2018 GROUP A PROPOSED CHANGES TO THE I-CODES COLUMBUS COMMITTEE ACTION HEARINGS

April 15–23, 2018
Columbus Convention Center
Columbus, Ohio

Publication Date: February 2018

FIGURE 3203.9(1)
EVALUATION BY VOLUME OF GROUP A EXPANDED PLASTICS IN MIXED COMMODITIES^{a, b}

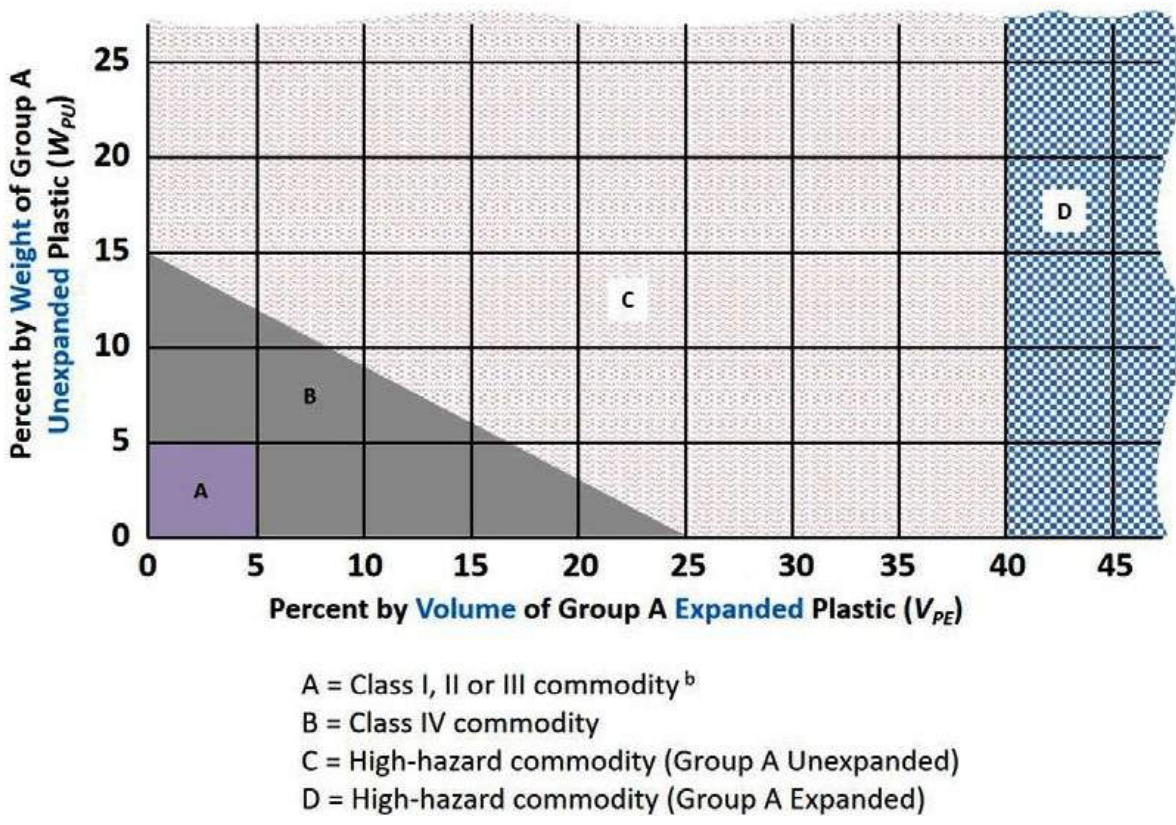
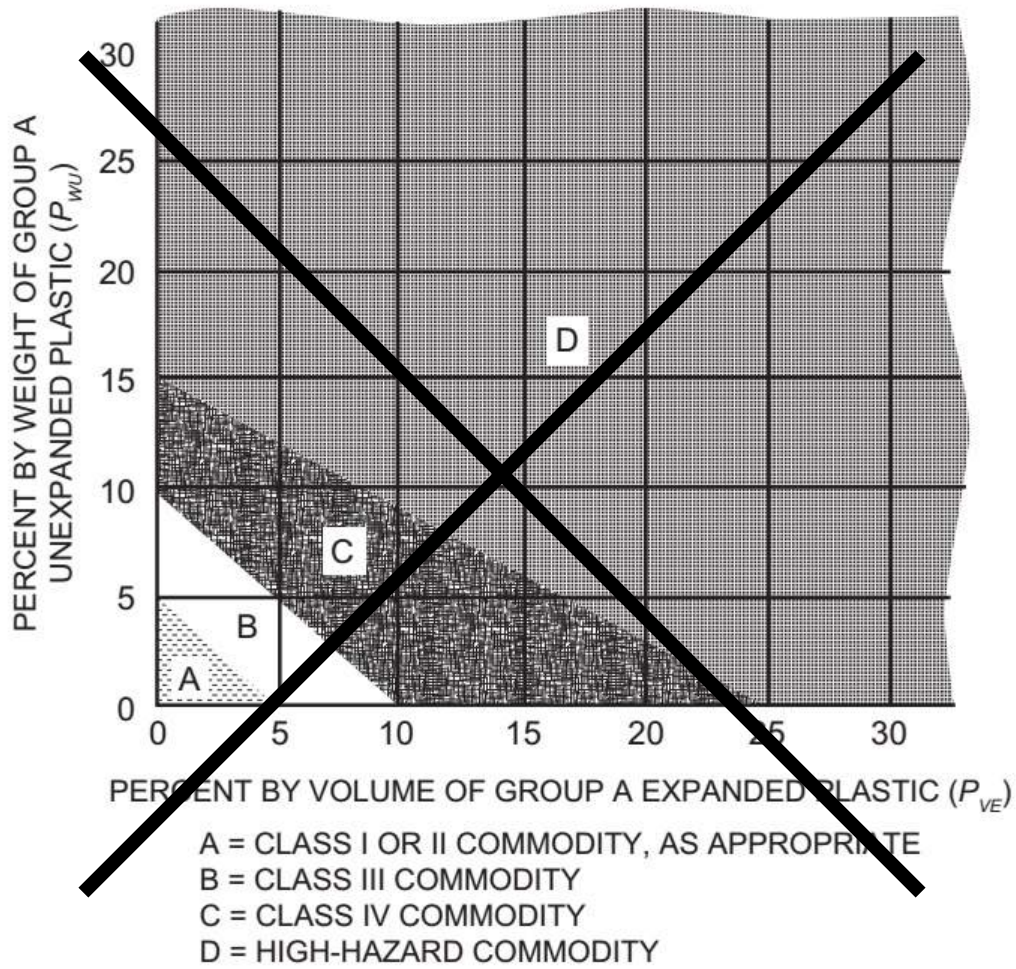
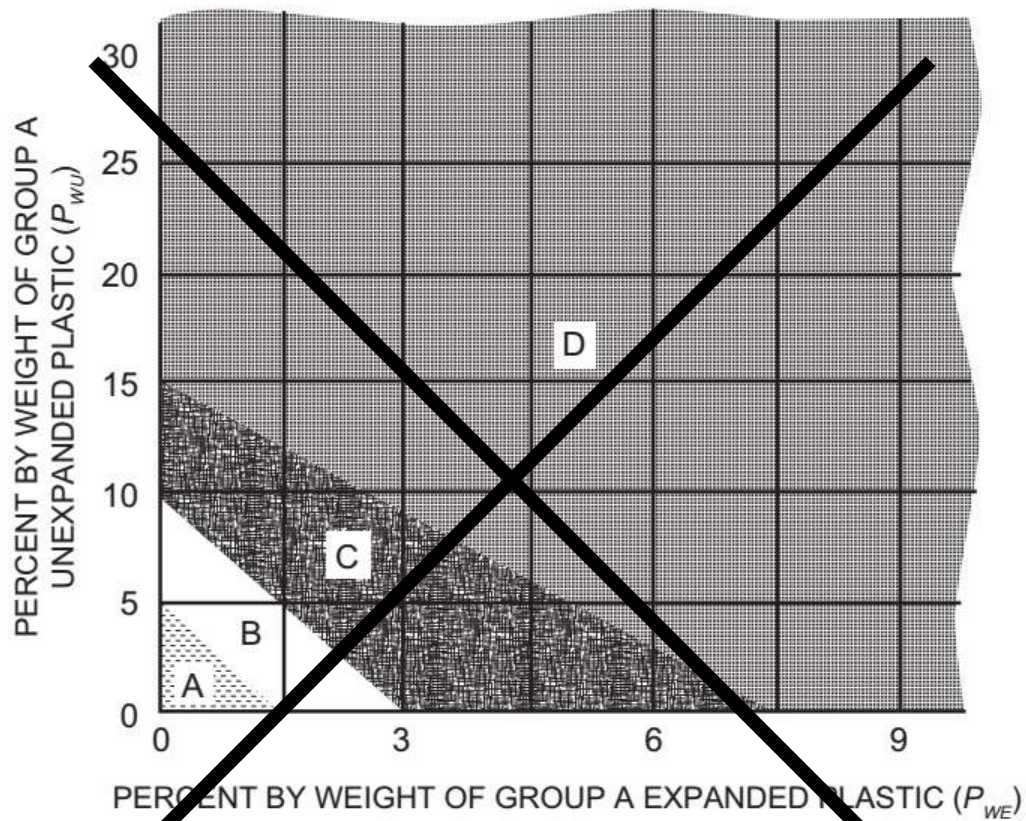
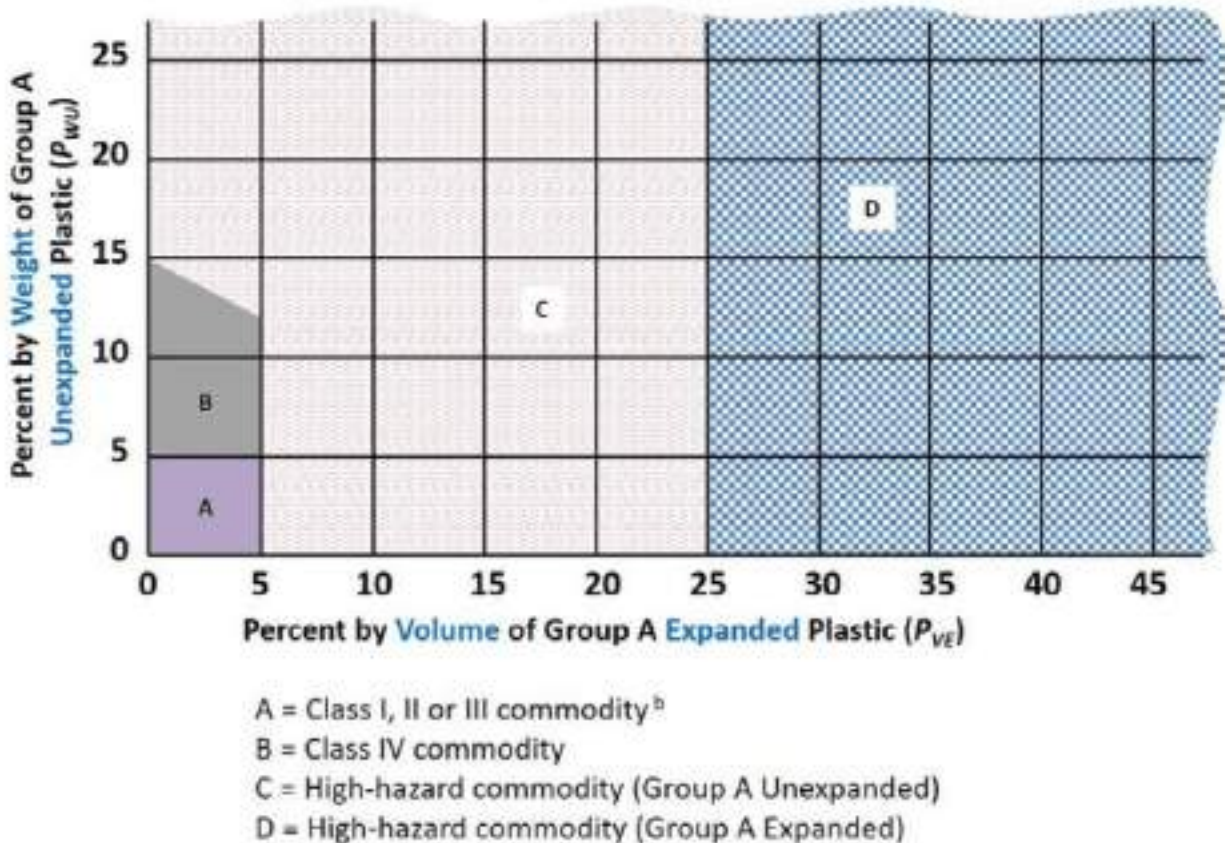
IFC: FIGURE 3203.9(1), FIGURE 3203.9(2)
